# nonlinear circuits

## Flipflop Chaos

build notes [version 2.2](#)

17 Mar 2015

**do not install  
leave empty**

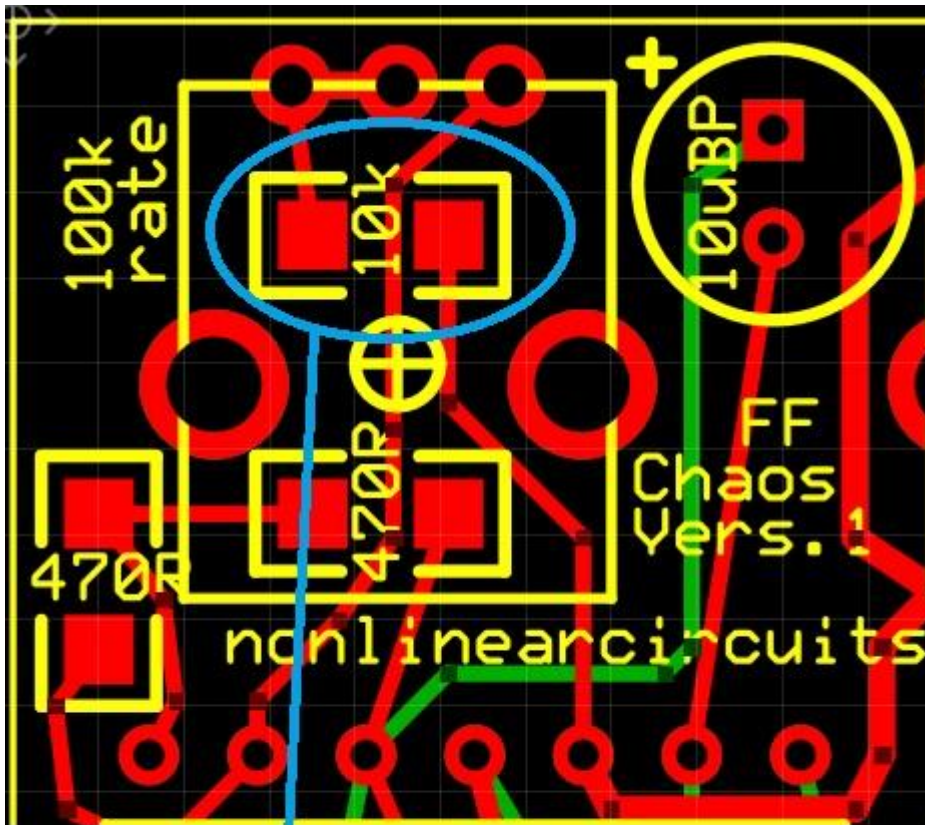
1. Do not install the three 100k resistors shown below, leave the pads empty. They are all on the underside of the PCB.

replace with 22k

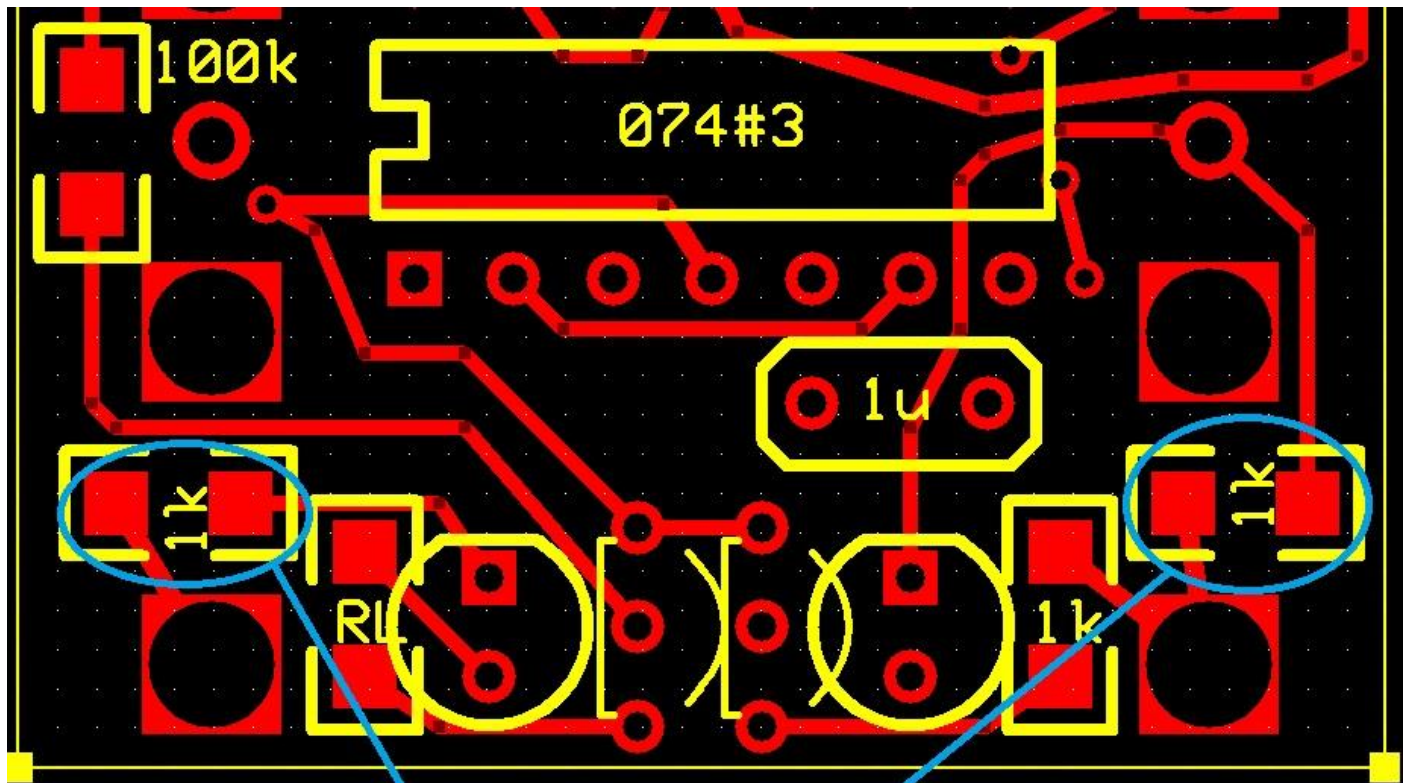
2. Replace 10k with 22k, this removes a dead zone at the bottom of the rate pot

replace with 2k

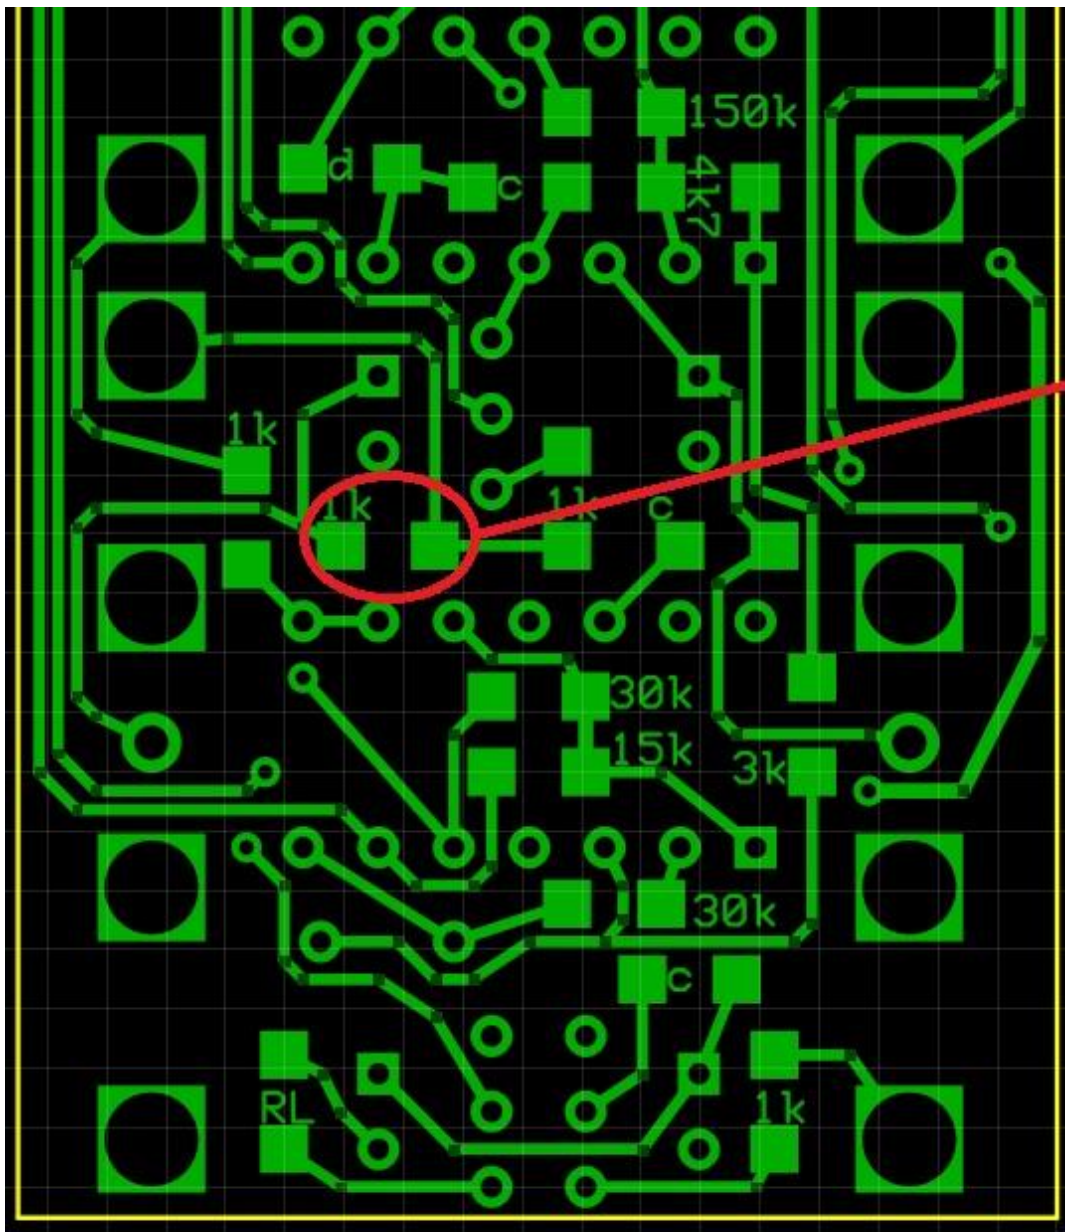
3. Change three 1k resistors to 2k. Two are on the upper side of the PCB, one is on the bottom
